TUALATIN ARCHITECTURAL REVIEW BOARD MEETING

1. Consideration of an Architectural Review application (AR 22-0001) for 116 unit multi-family development on a 4.68 acre site in the High-Density Residential (RH) zone at 23500 SW Boones Ferry Road (Tax Lot: 2S135D000303).

TO: Architectural Review Board

Consideration of an Architectural Review application (AR 22-0001) for a 116 unit multi-family development on a 4.68 acre site in the High-Density Residential (RH) zone at 23500 SW Boones Ferry Road (Tax Lot: 2S135D000303).

STORMWATER PLAN - SOUTHWEST

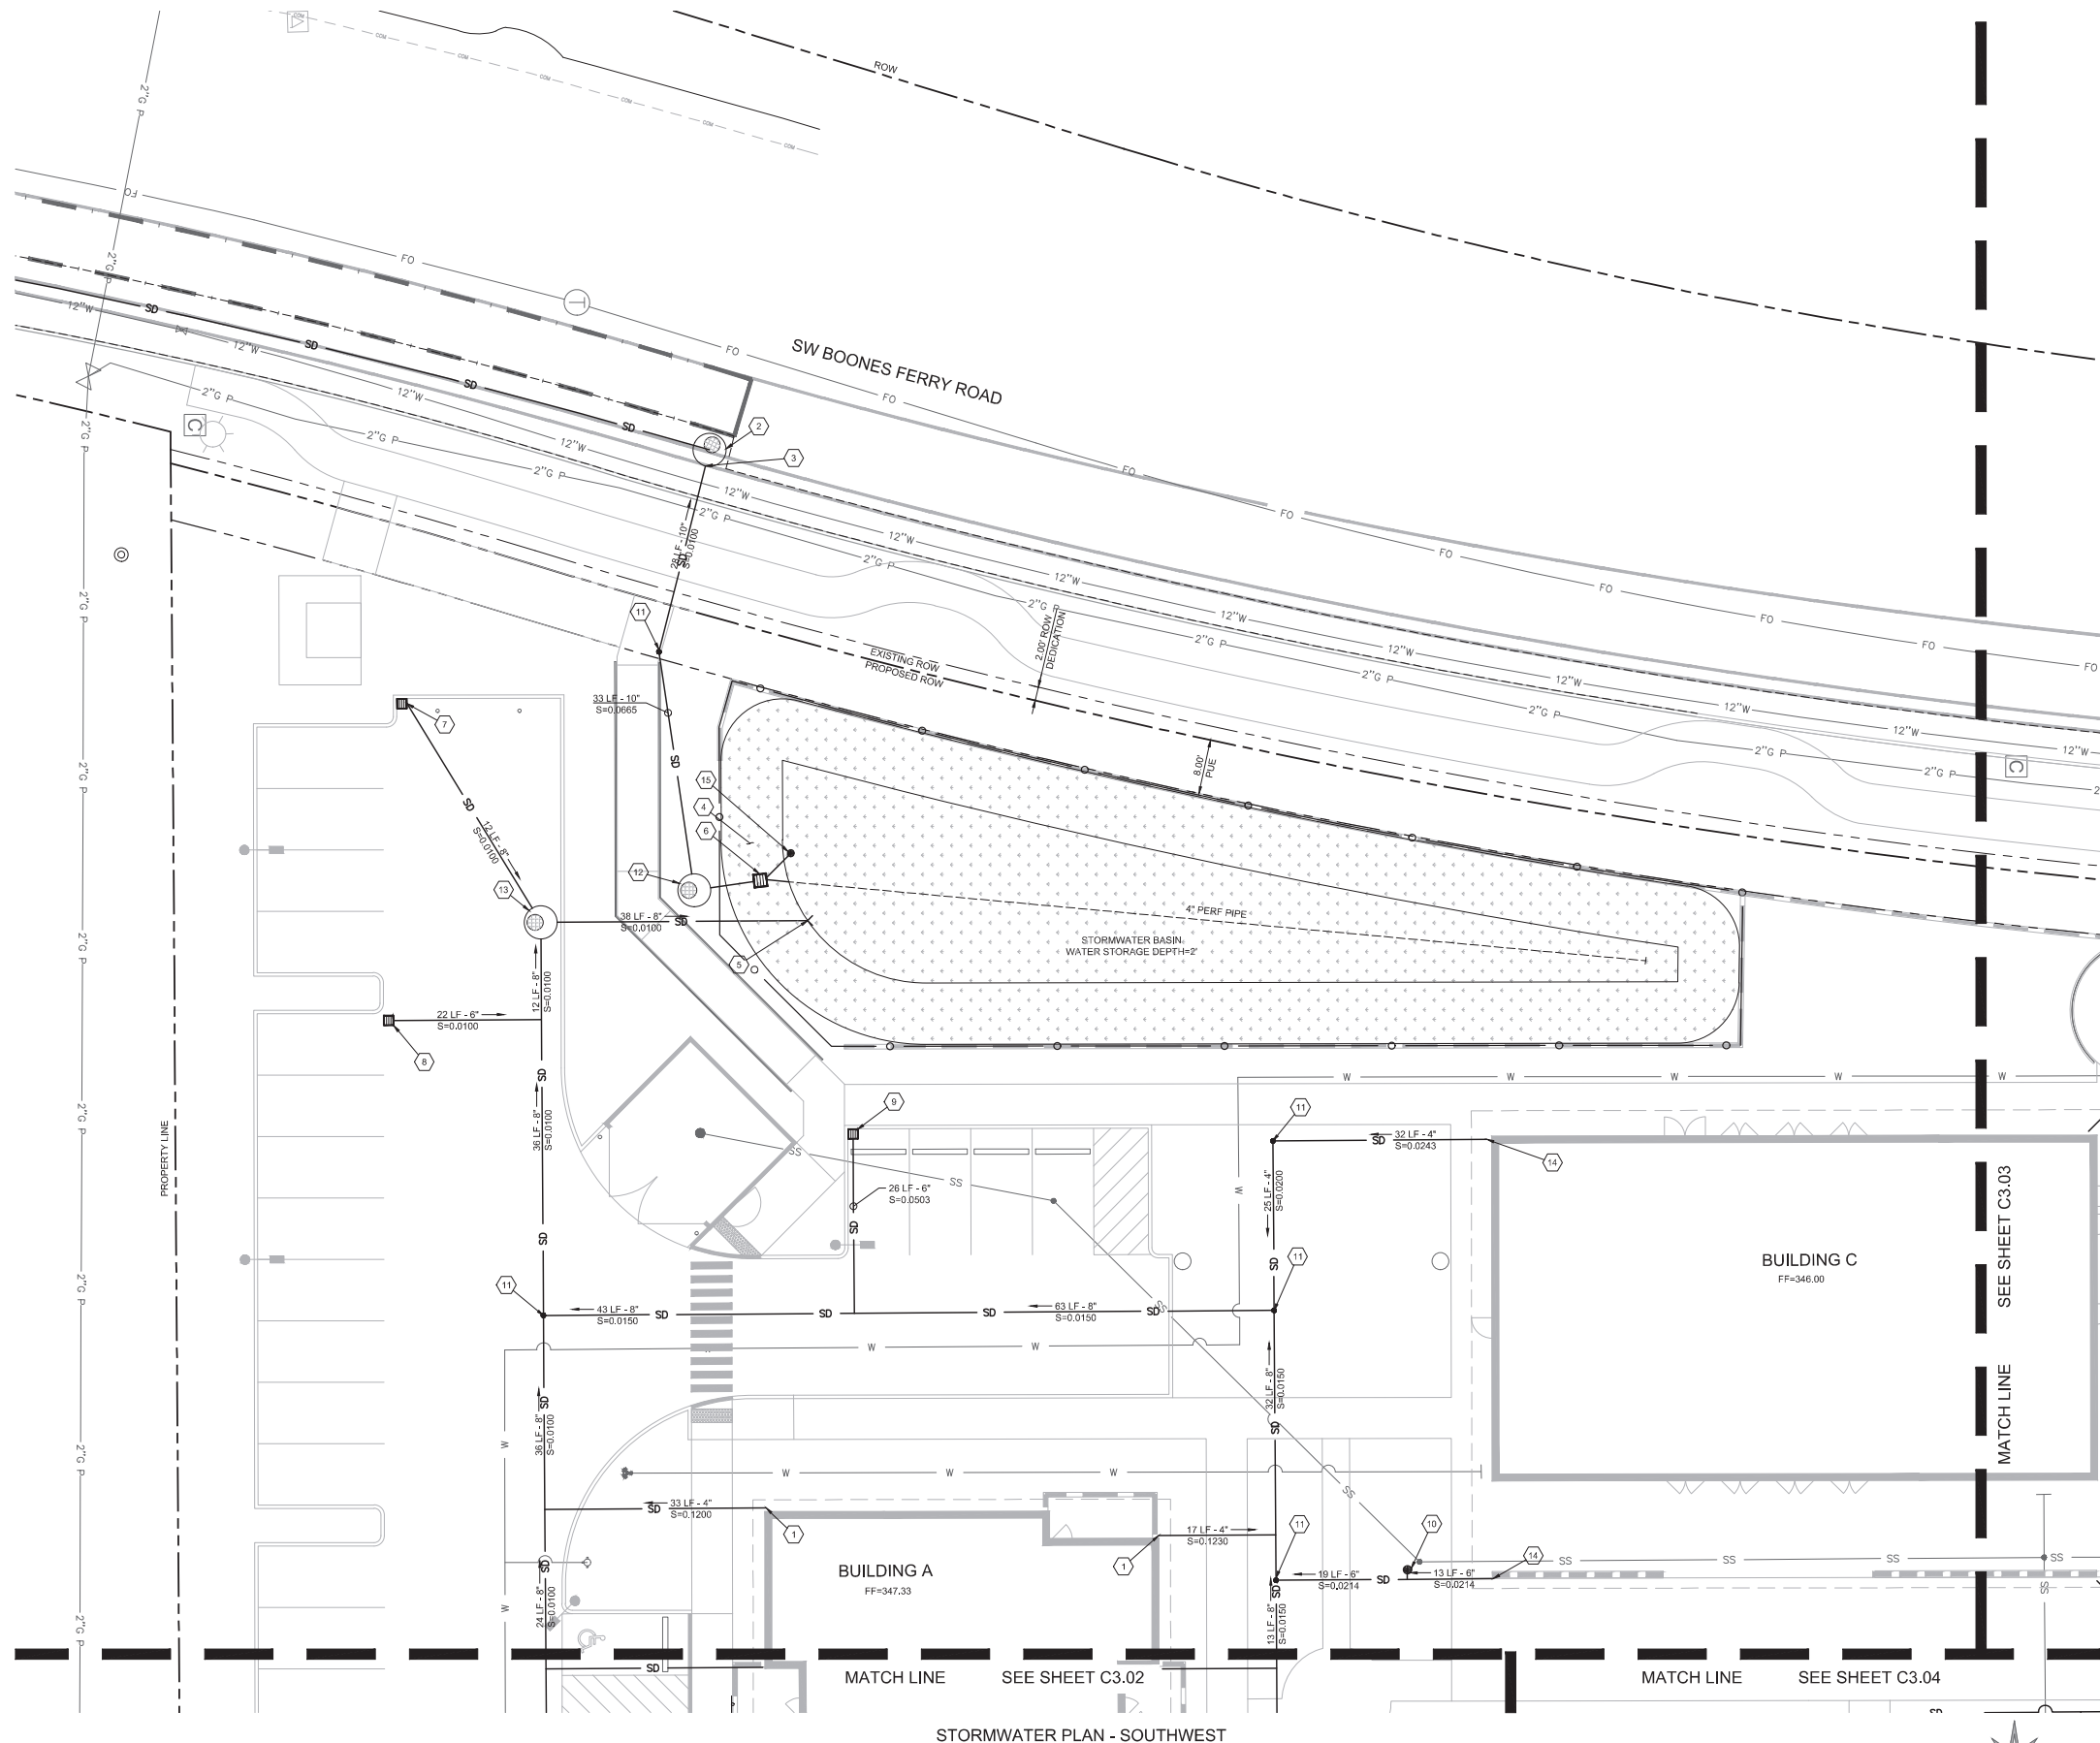
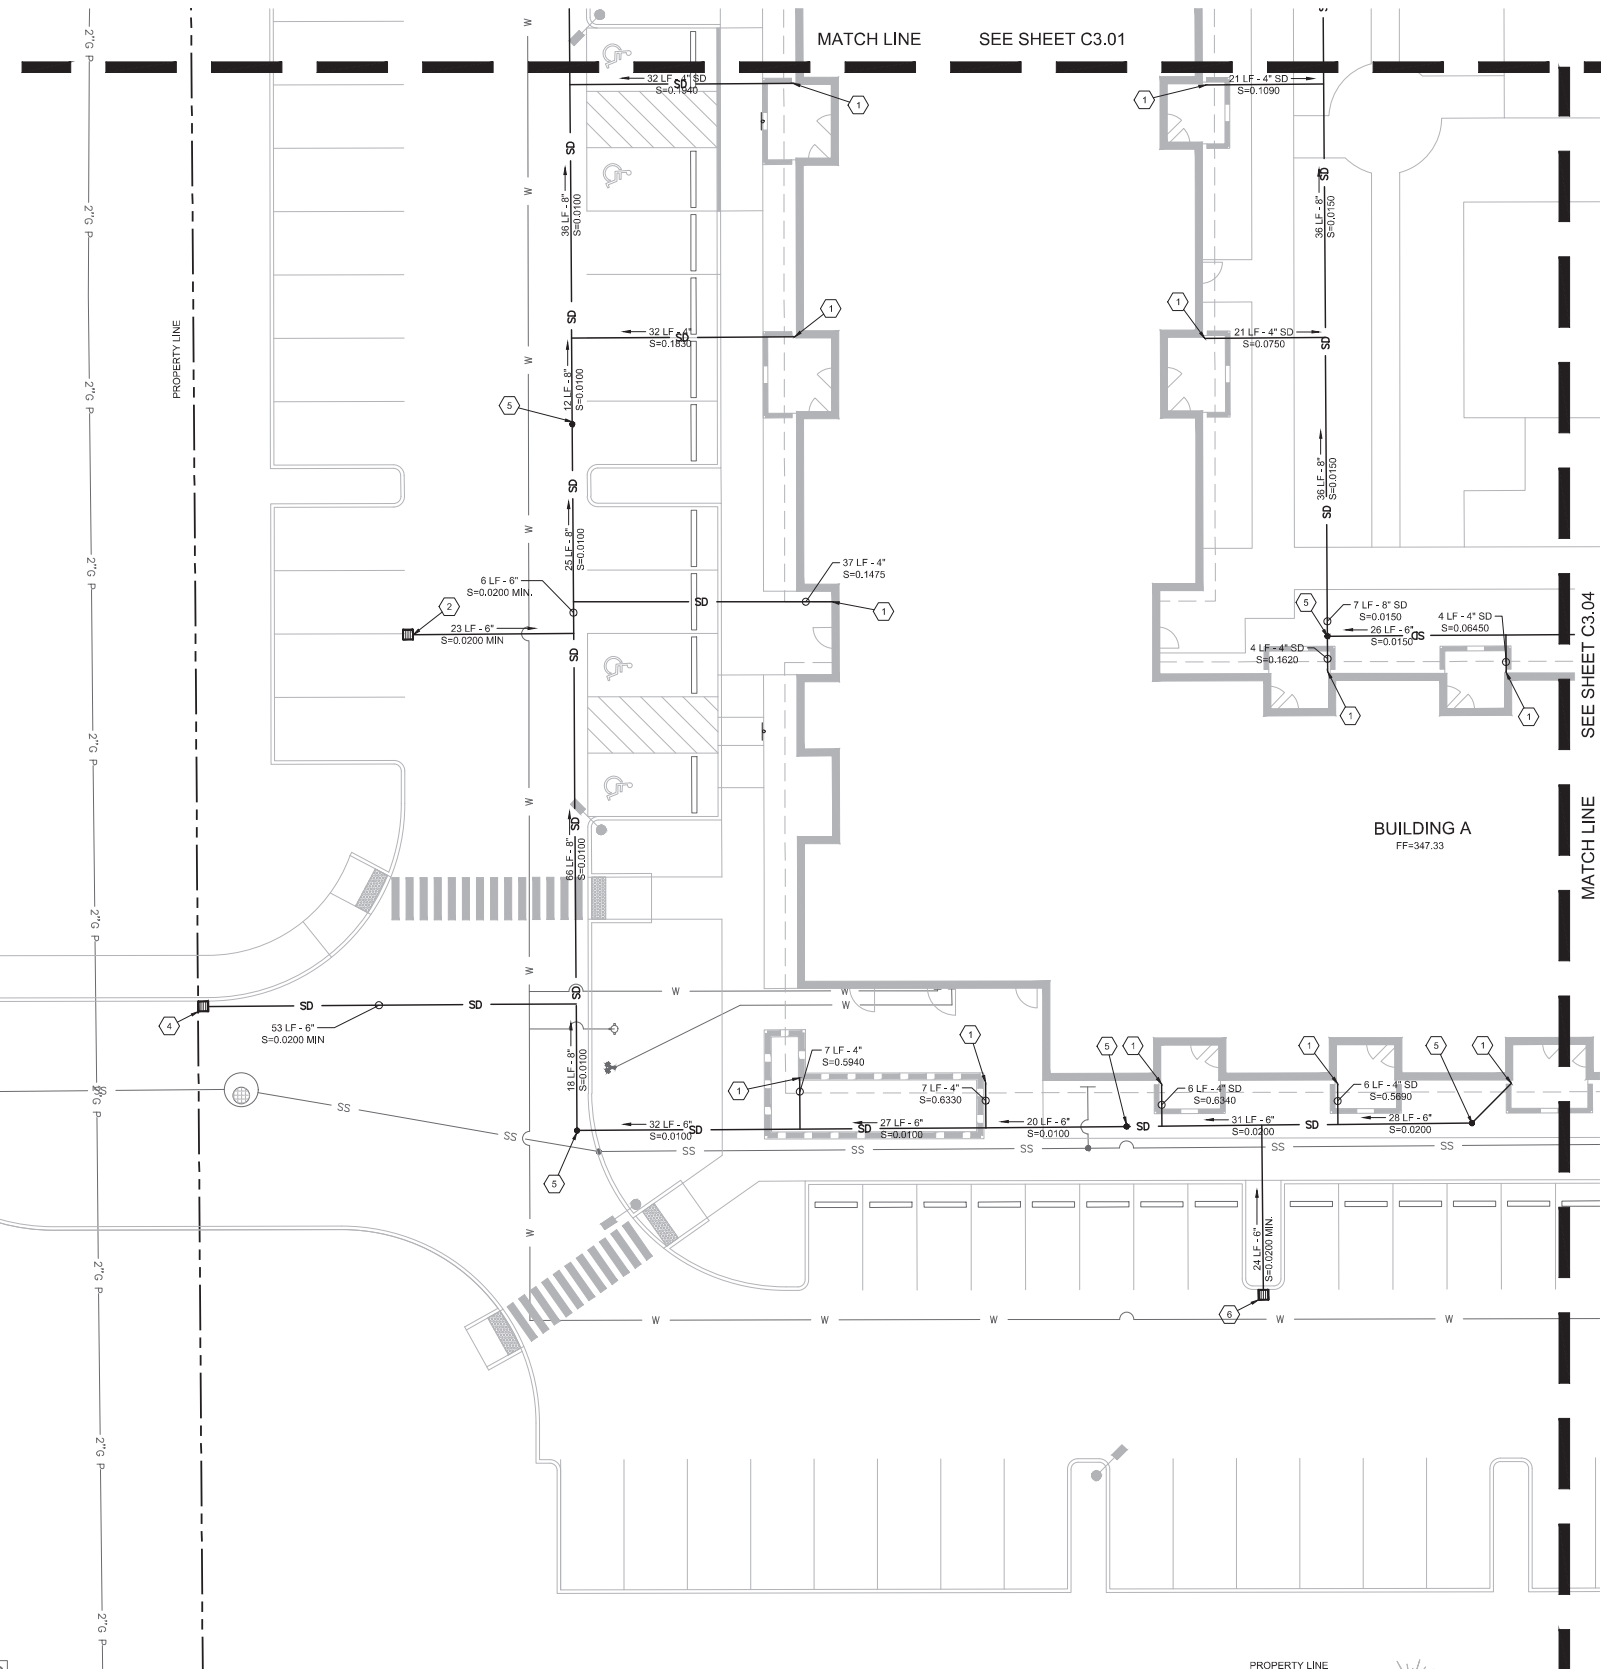
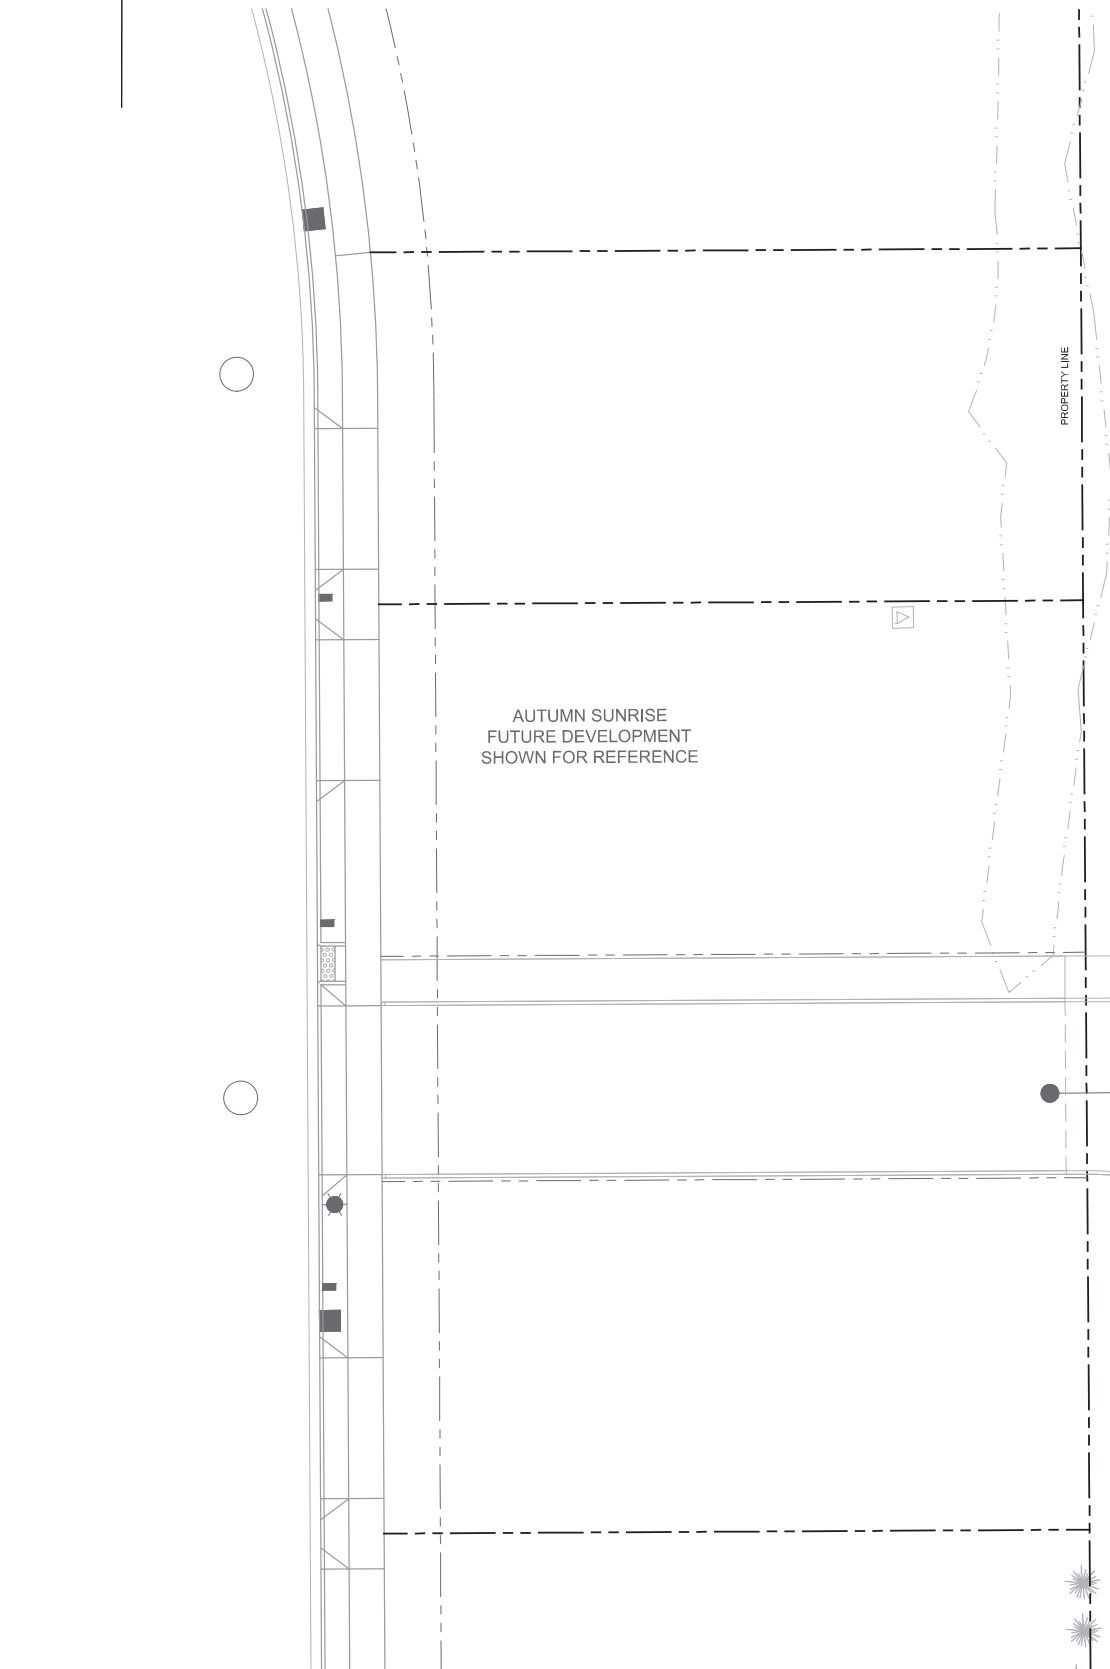
There appears to be conflicting information between these statements within **the 5-2-22 Drainage Report Southern Basin** information ----and the **Plan Set Map C3.01 Stormwater Plan Southwest** (both on the map and in the accompanying Stormwater Notes) submitted for the ARB 6-8-22 meeting.
